LAND USE APPLICATION SUMMARY

Property Location: 2415-2423 2nd Street Northeast
Project Name: Western Line on Second
Prepared By: [Aaron Hanauer](#), City Planner, (612) 673-2494
Applicant: Jeremy Rupp, Concord Universal Development
Project Contact: Jeremy Rupp
Request: To construct a two-building, seven-unit cluster development.
Required Applications:

Conditional Use Permit	To allow a two-building, seven-unit cluster development in the R3/Multiple-Family District.
Variance	To allow an increase in the maximum accessory structure floor area for a detached garage from the allowed 2,041 square feet (10 percent of the lot area) to 2,842 square feet.
Site Plan Review	For a two-building, seven-unit cluster development in the R3/Multiple-Family District.
Preliminary and Final Plat	To allow for the cluster development

SITE AND DIMENSION PLAN

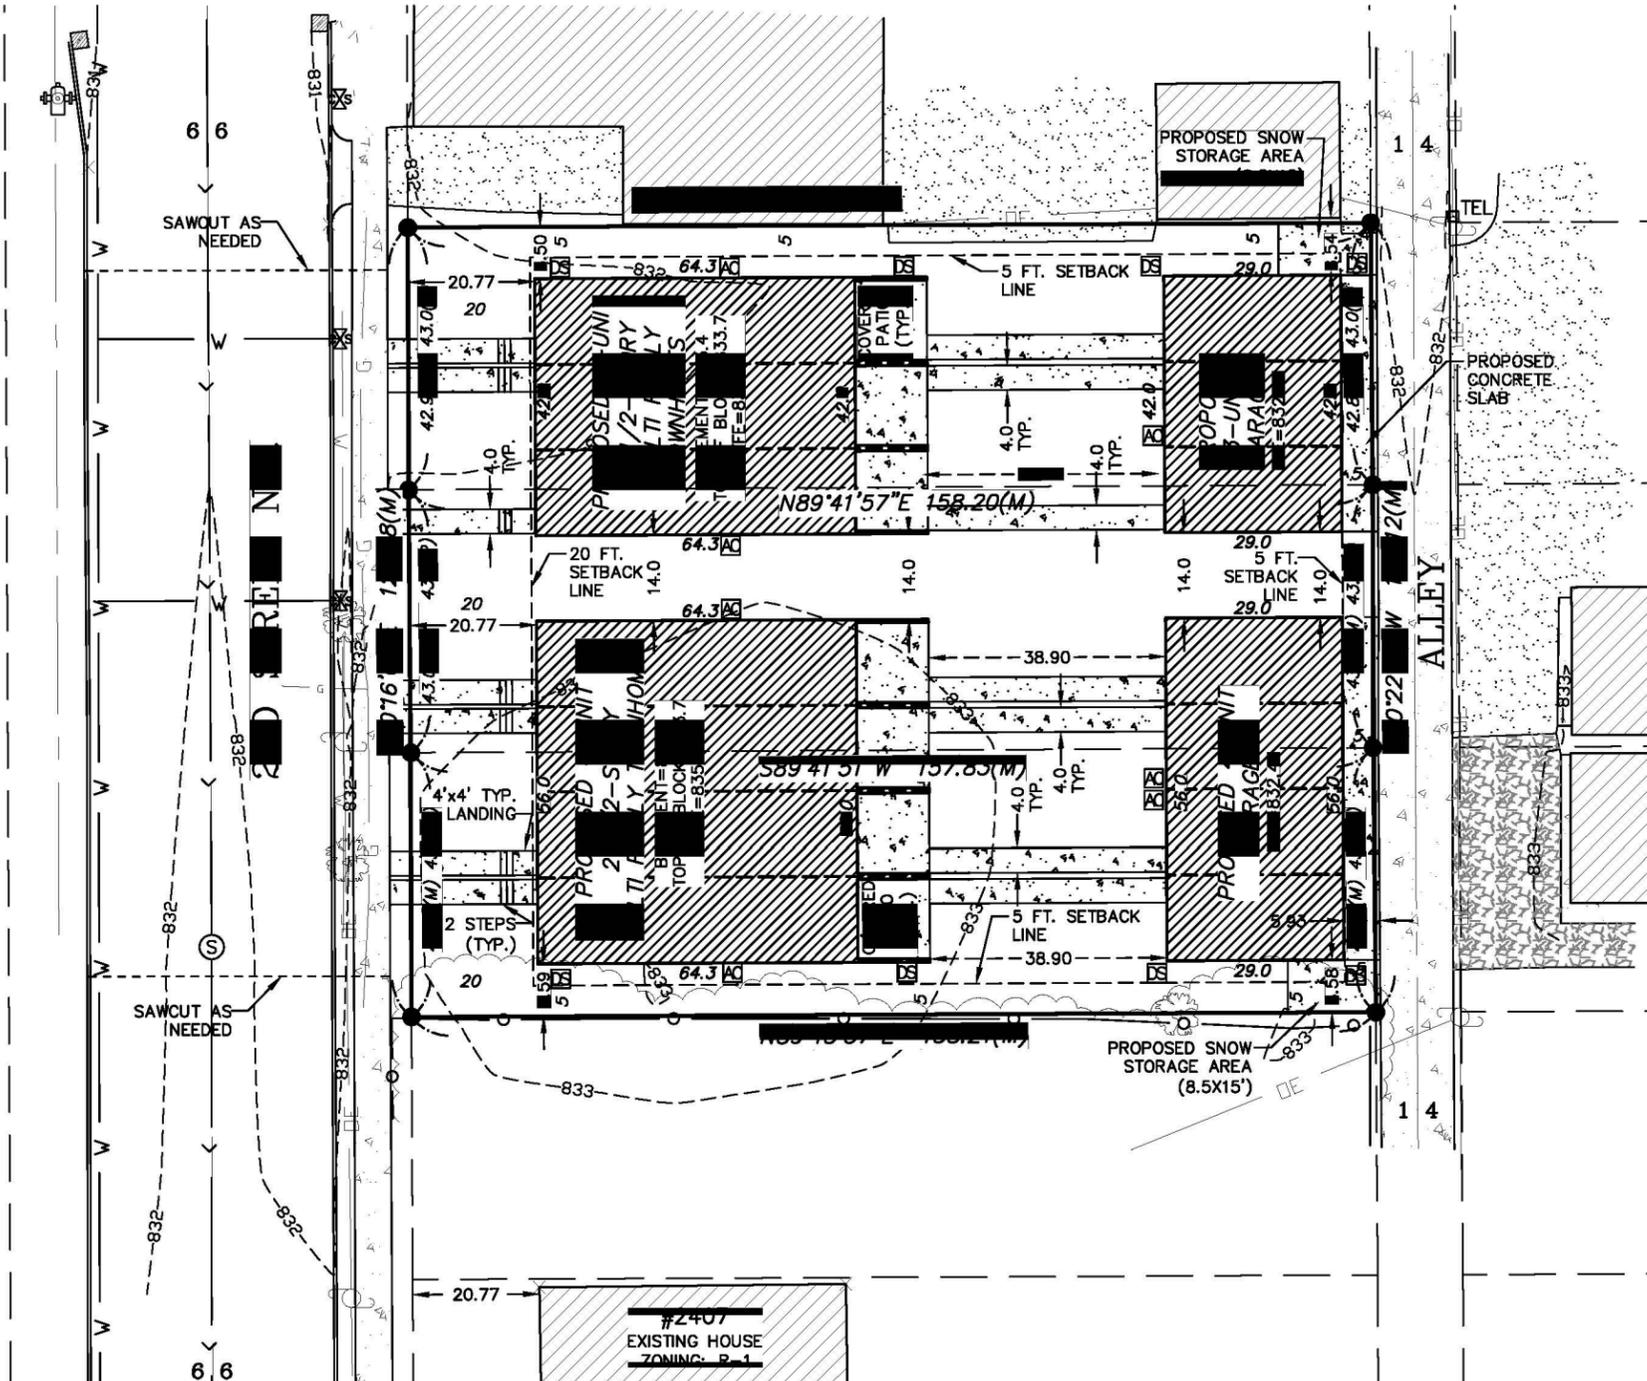
- All existing and proposed underground Public Utilities (water, sanitary sewer, and storm drain) shall be shown on the site plan with corresponding pipe sizes and types. For Public watermain infrastructure records call (612) 673-2865. Any existing connections not in use shall be noted on the plans for removal, and shall be removed per the requirements of the Utility Connections Department, call (612) 673-2451 for more information.
- Water service line sizes need to be specified for each individual service and if these lines are domestic only. Please contact Rock Rogers at (612) 673-2286, to review domestic and fire service design, connections, and sizes.

- Please identify the location of any proposed foundation drain tile connections or discharges.
- Utility Connections: Please verify if the common area outside the buildings will be owned and maintained by an association. If so, it may be more appropriate to make one connection to the City main for the sanitary sewer service connection, with branch line serving each unit off that. Please contact Jeremy Strehlo, 612-673-3973, for further direction on the sanitary sewer service connections.

- Non Stormwater Discharges: Detail all mechanical and non-stormwater discharges. Non-stormwater discharges are not permitted unless approved by the City of Minneapolis. Non-stormwater discharges not declared and approved will not be permitted. If there currently are none and nothing is proposed declare this status on the plans.

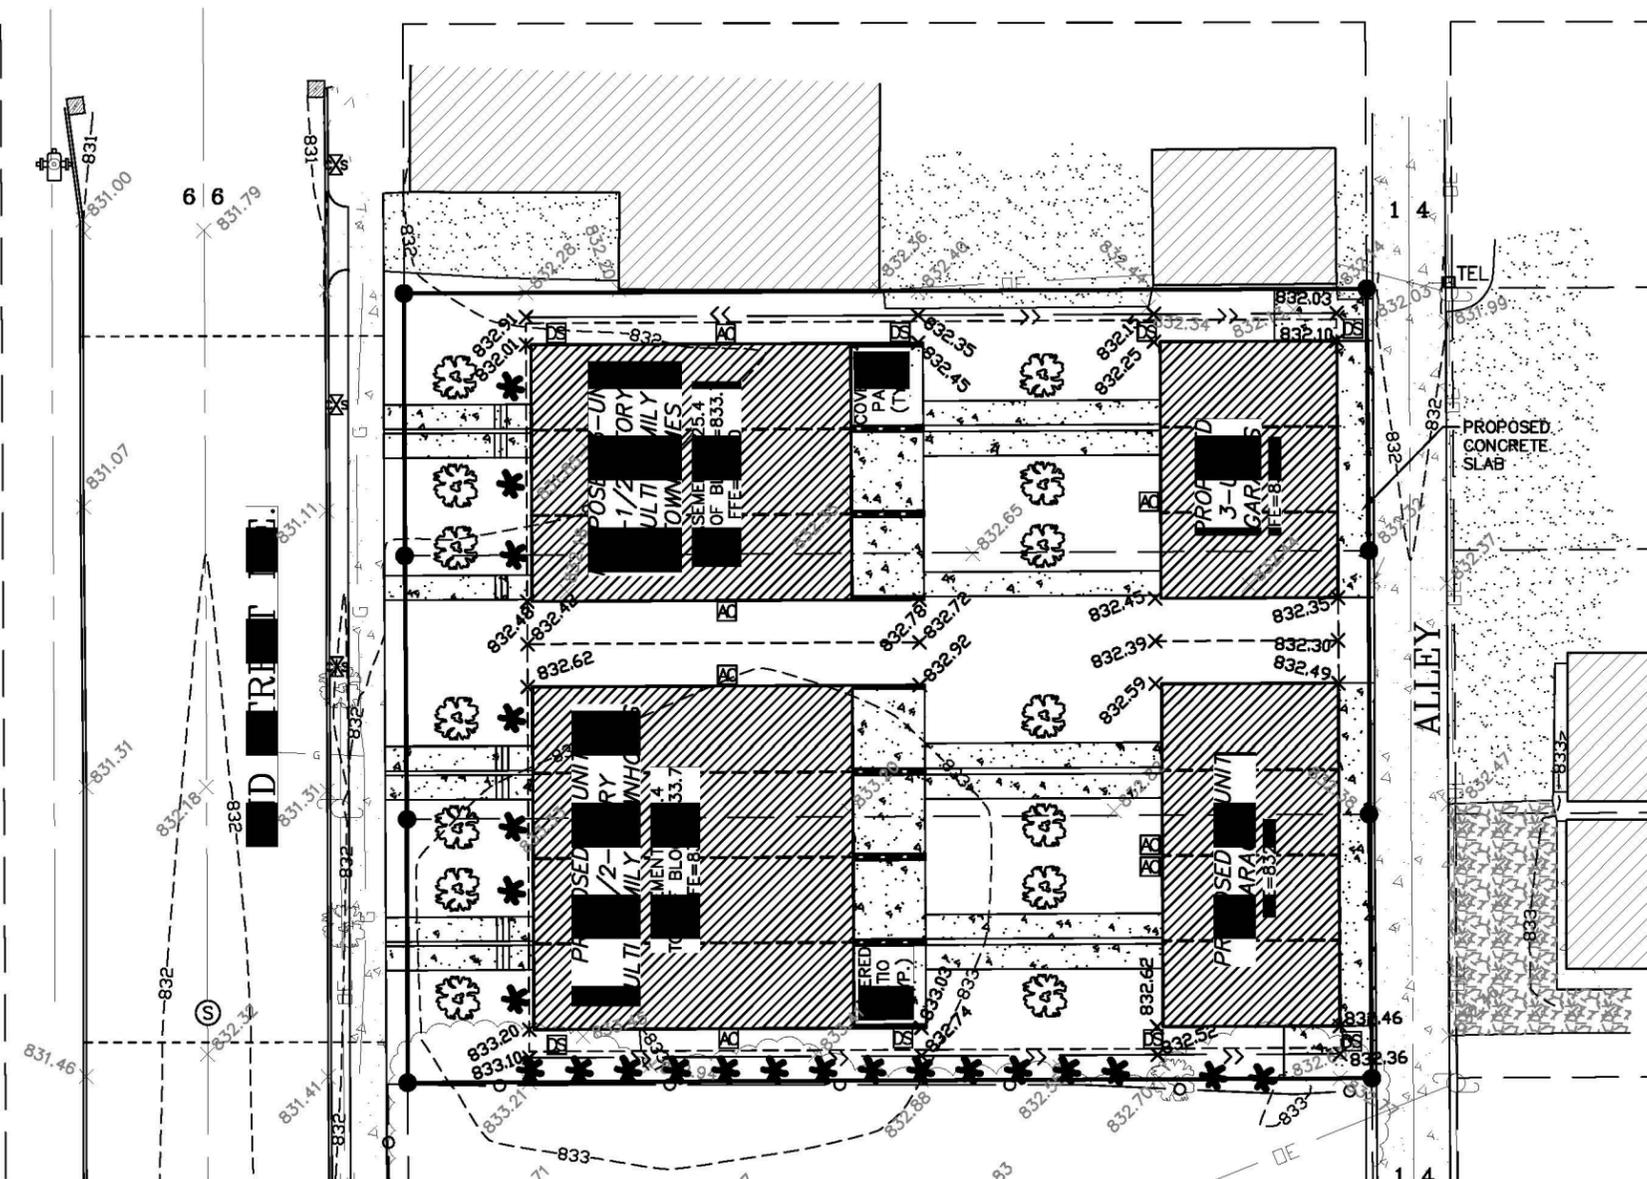
- Erosion Control: The erosion and sediment control notes on Sheet 3 of 3 appear to be related to a different project. Please update these to reflect this project.

NO.	DATE	DESCRIPTION	BY
1	3/13/15	REV. PER CITY COMMENTS	BN
2	4/10/15	REV. PER CITY PDR REPORT	BN
